ADDENDUM NO. 1

Bid #1506
ORANGE EDUCATION CENTER PORTABLES PHASE II
at
ORANGE EDUCATION CENTER

Project ID #3762, DSA #04-125366

ADDENDUM 1

A4.04-2

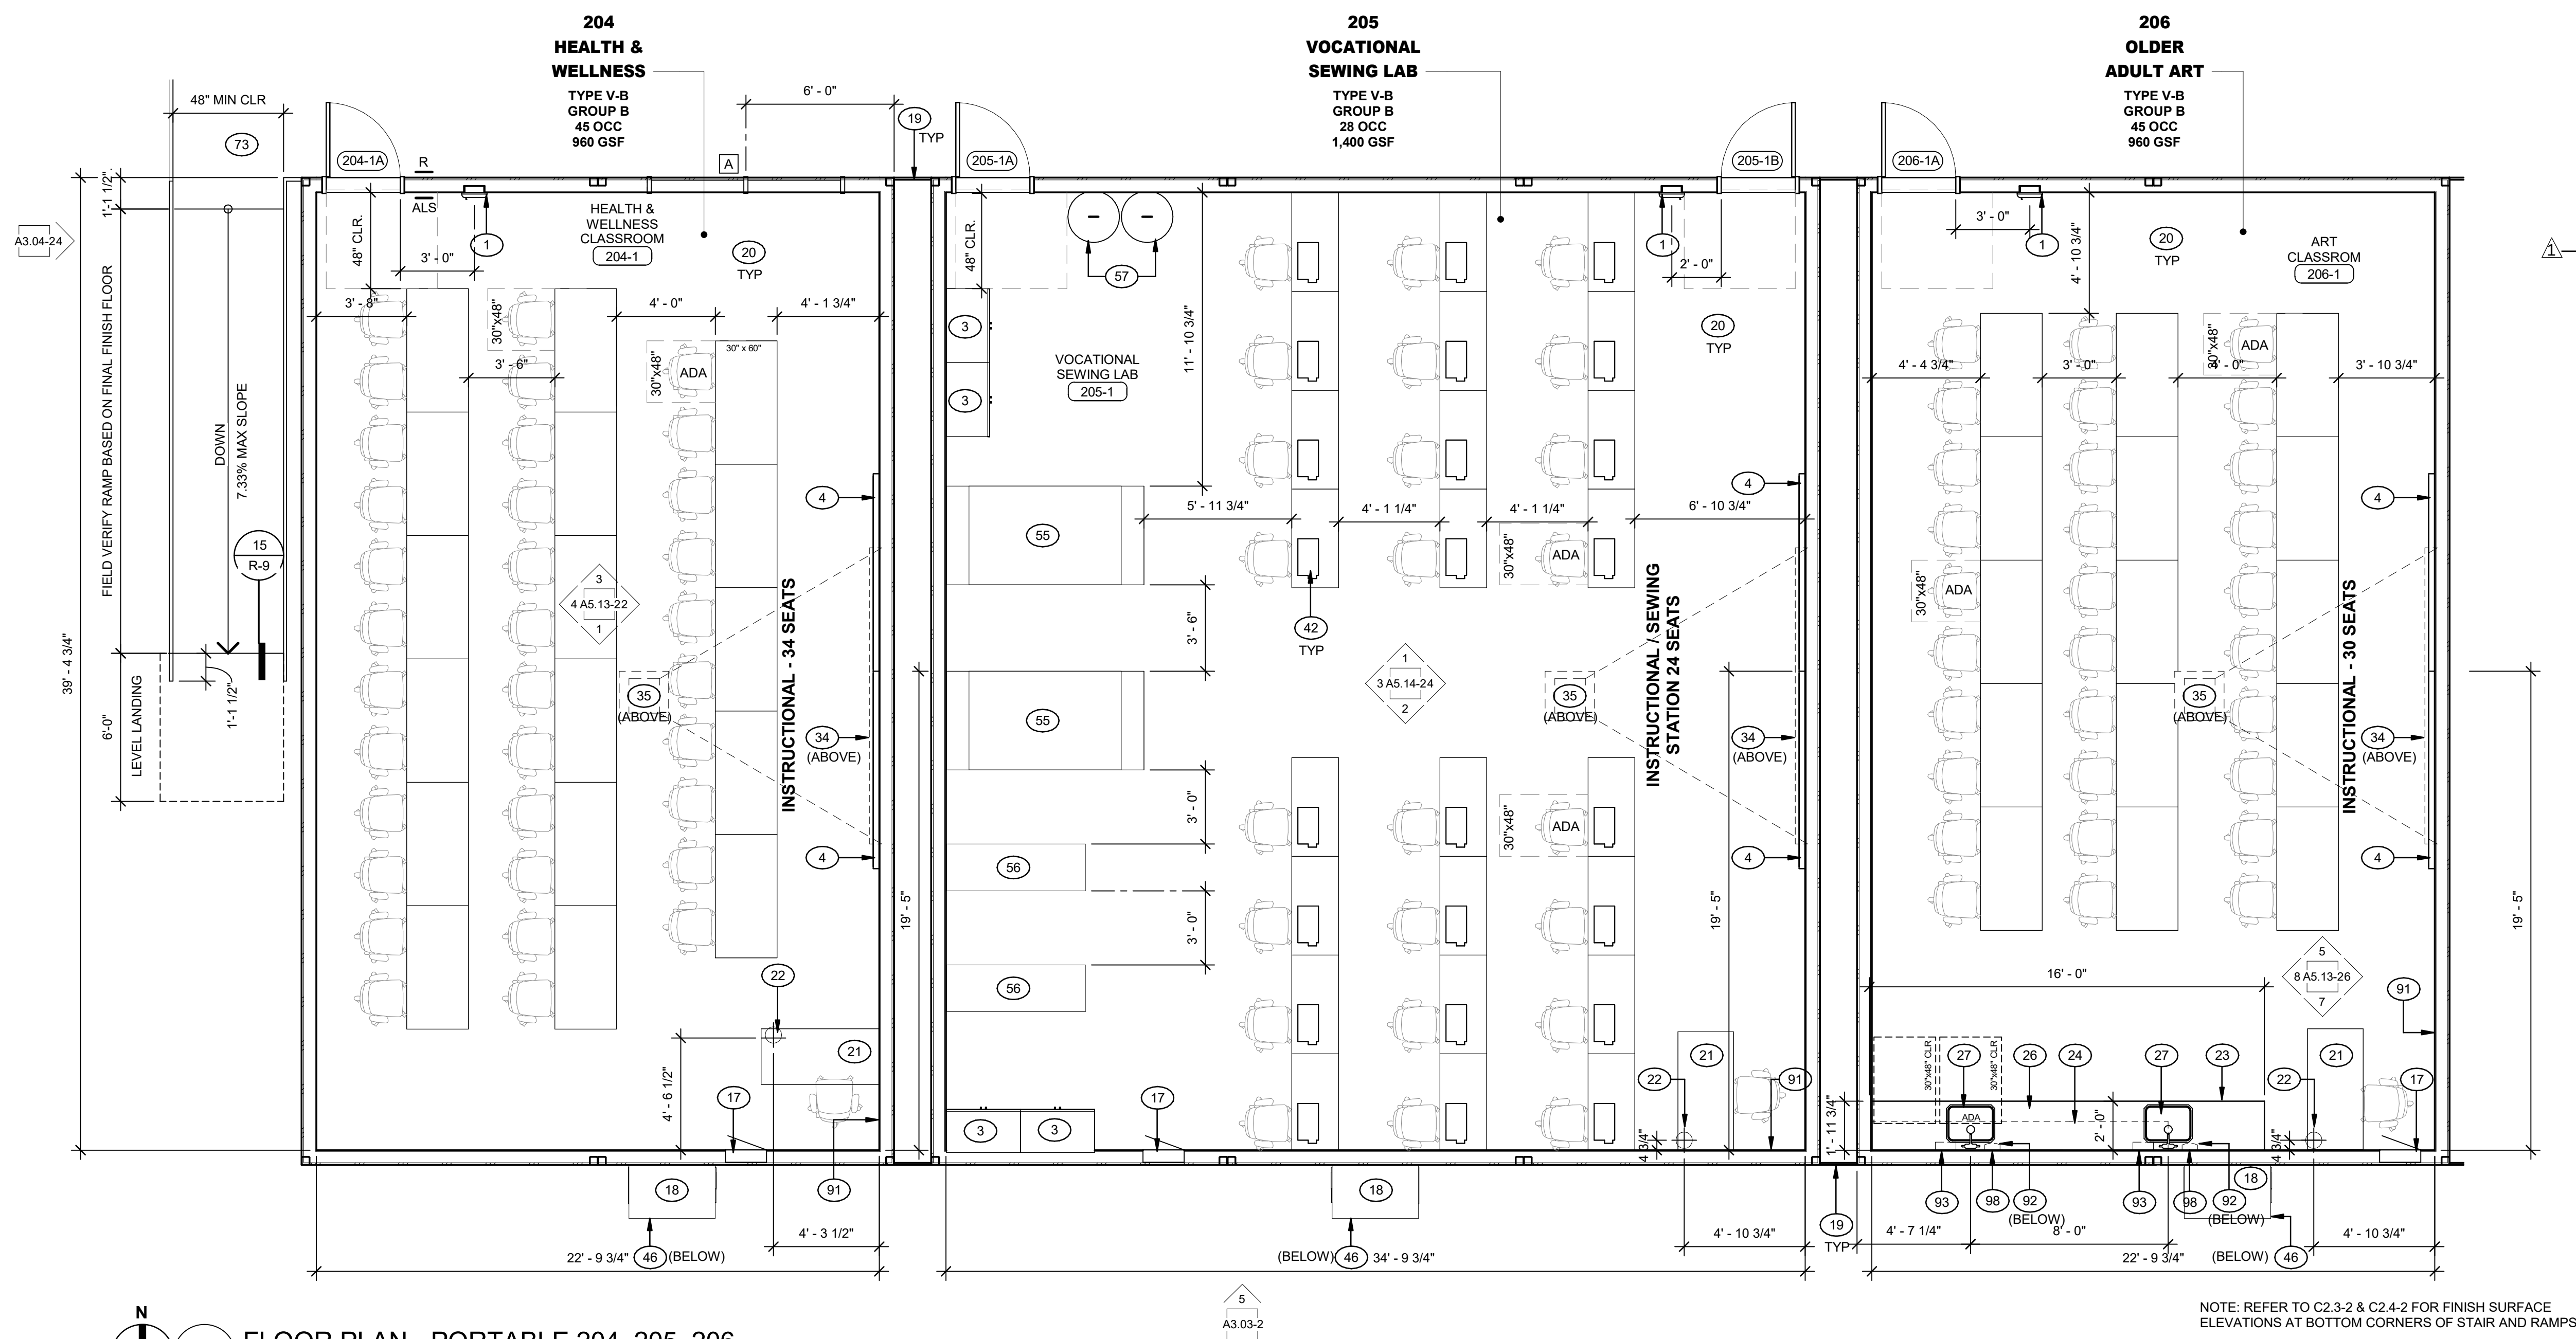
3. **A2.02-2:**
 - A. Casework has been updated in Portable 207.
 - B. Furniture configuration has been updated to reflect changes to layout by furniture vendor.
4. **A4.04-2:**
 - A. The reception desk has been revised to reflect changes in the District's furniture vendor's layout.

A4.05-2

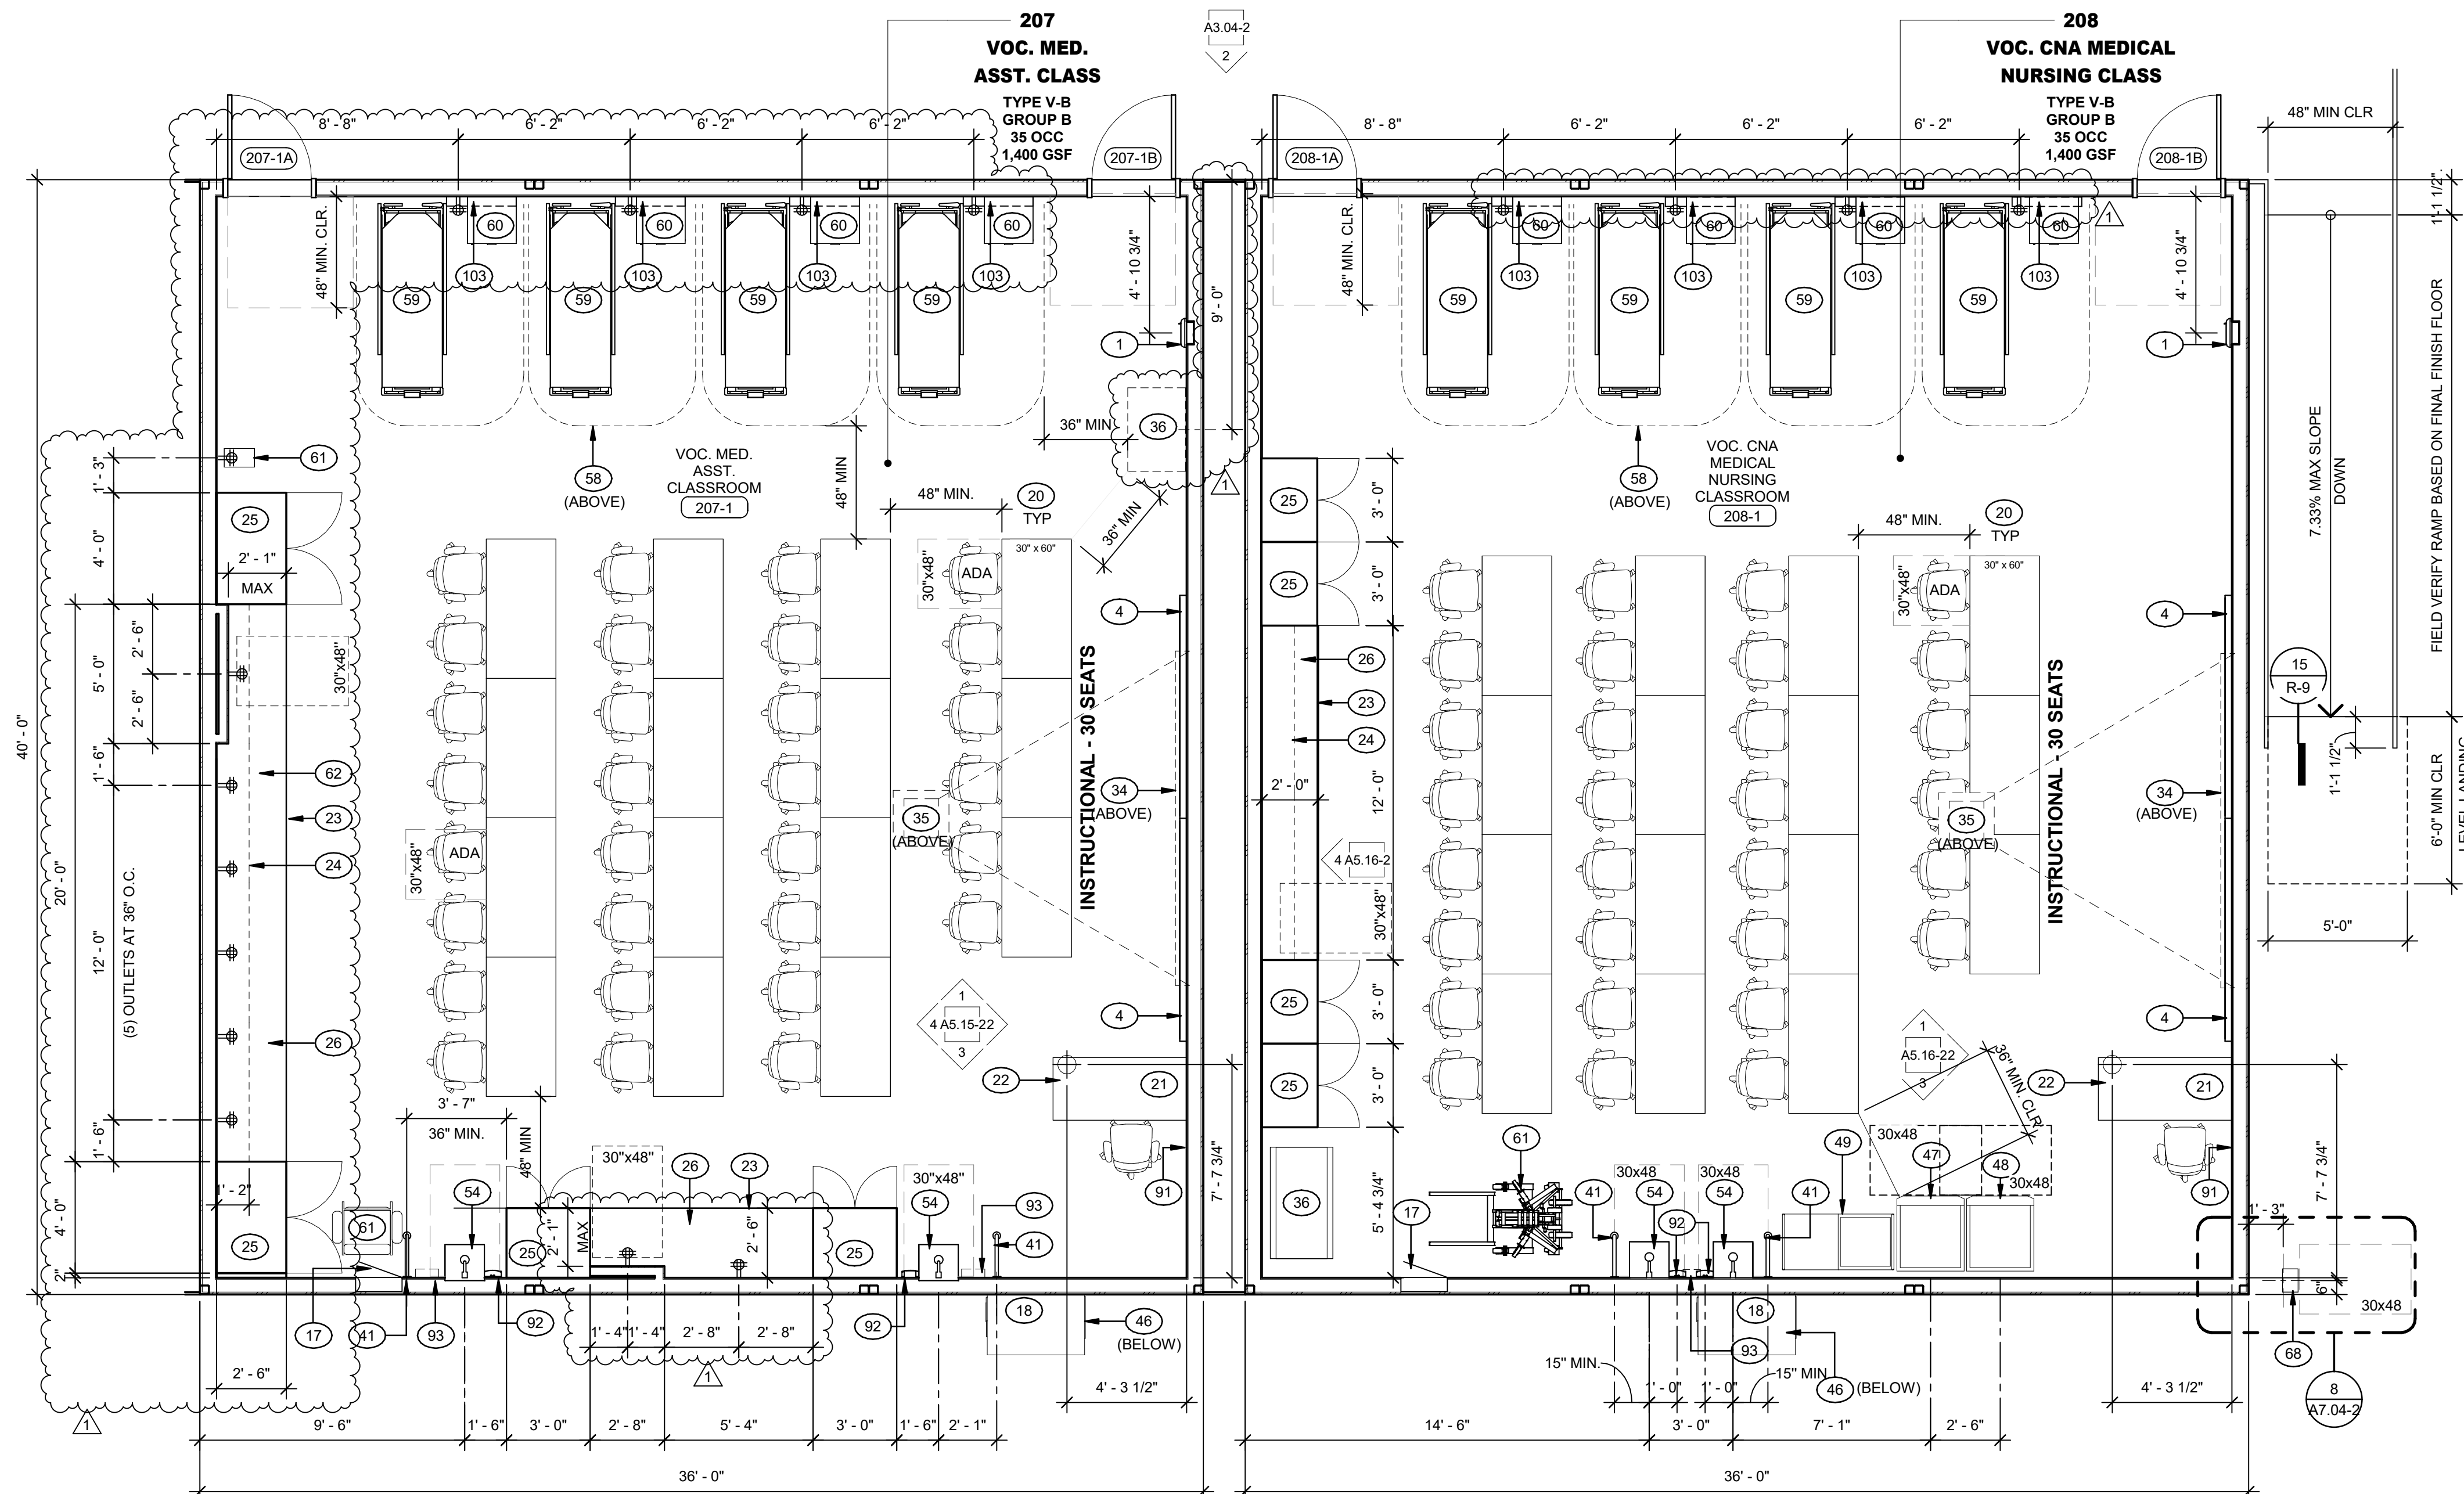
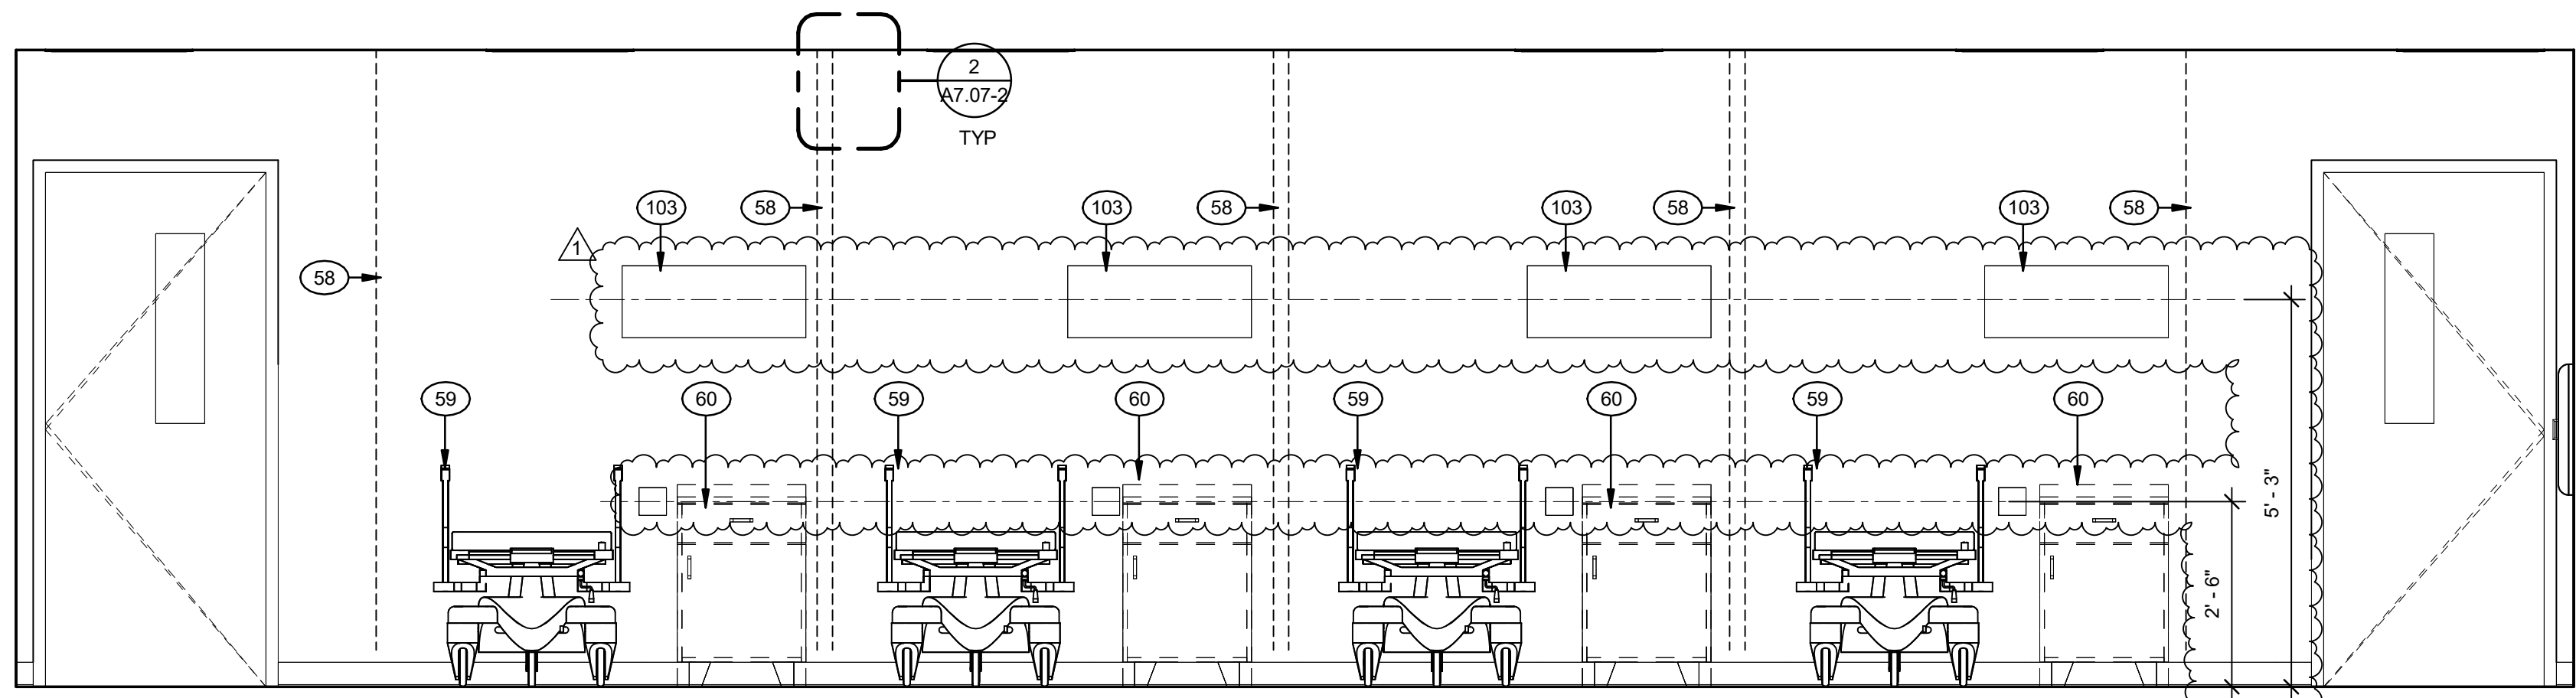
5. **A4.05-2:**
 - A. Portable 207 has casework configuration modifications to accommodate program needs per 9/10/26 meeting with the user group. The wall has been furred at counters where accessibility is provided.
